URGENT: Medical Device Recall Notification

AFFECTED DEVICE: Alaris™ Pump module Model 8100

June 12, 2017

Figure 1 - Image of Centered-Sear Safety Clamp Fitment (Affected Product - Sequester)

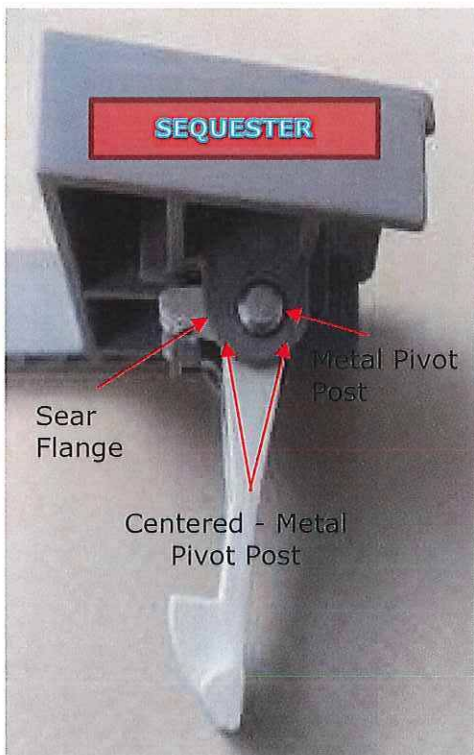
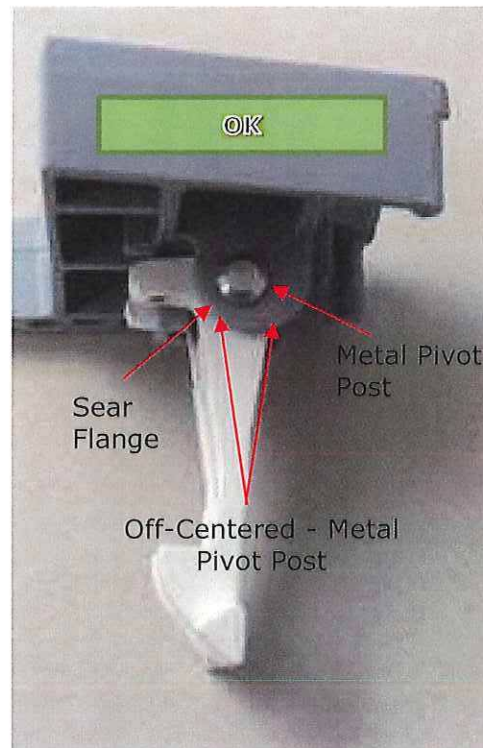
Using Figures 1 and 2 as a reference, visually examine the affected device to determine if the door latch has a centered-sear flange (the door latch mechanism may have been replaced after manufacture with an off-centered sear design). The centered-sear safety clamp fitment is identified by the centered position of the metal pivot post located on the inside of the door latch assembly sear flange.

- If your device has a centered-sear safety clamp fitment (Figure 1), clearly mark and sequester (e.g. Biomed department) the Alaris Pump module. Notify BD Support Center at 888-562-6018 or SupportCenter@carefusion.com to coordinate an onsite remediation or send the devices to the BD Service Depot.
- If your device has an off-centered safety clamp fitment (Figure 2) the device does not require remediation.

Figure 2 - Image of Off-Centered-Sear Safety Clamp Fitment (Current Production - OK)

Image of Centered-Sear Safety Clamp Fitment
(Affected Product)

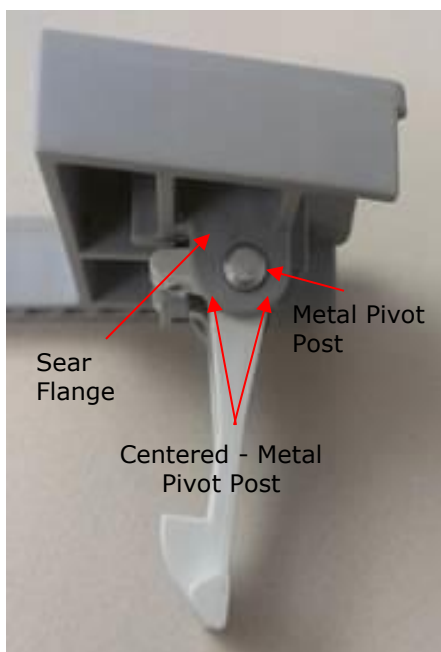
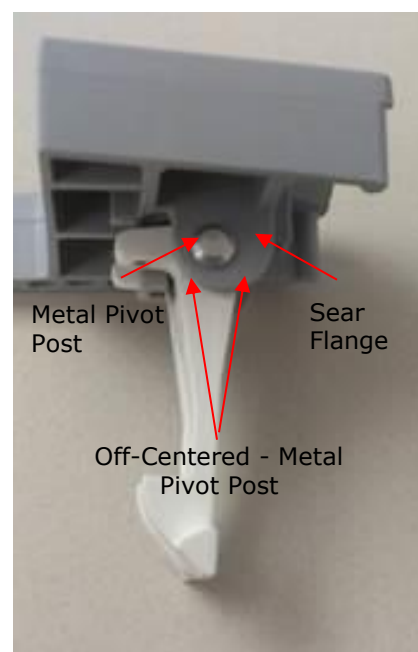
16. How can the user visually identify the Alaris Pump module door latch for a centered-sear?

The centered-sear safety clamp fitment is identified by the centered position of the metal pivot post located on the inside of the door latch assembly sear flange.

Image of Off-Centered-Sear Safety Clamp Fitment
(Current Production)
